SHUTE, MIHALY
& WEINBERGER LLP

July 31, 2012

Re: San Rafael Airport Recreational Facility

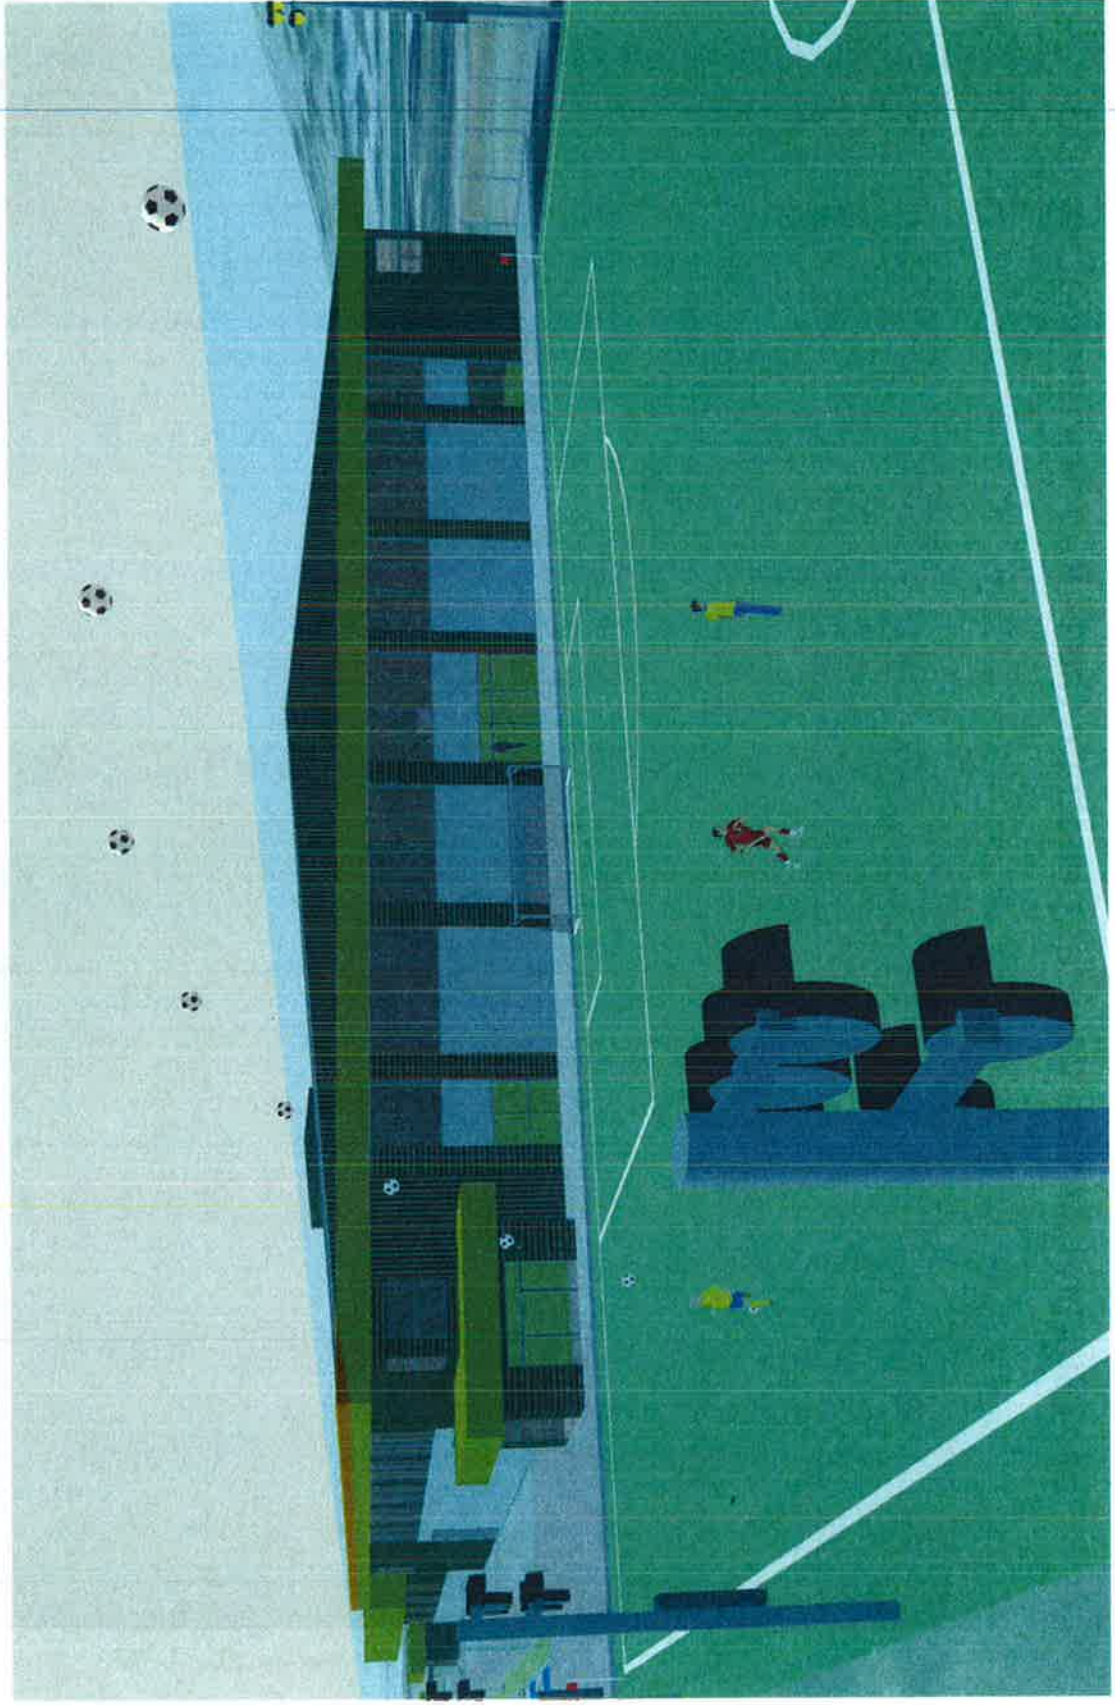
Team Bus and Service Vehicles penetrate the FAR 77 Transitional Surface

Soccer ball kicked 35 feet in air penetrates the FAR 77 Transitional Surface by 10+ feet
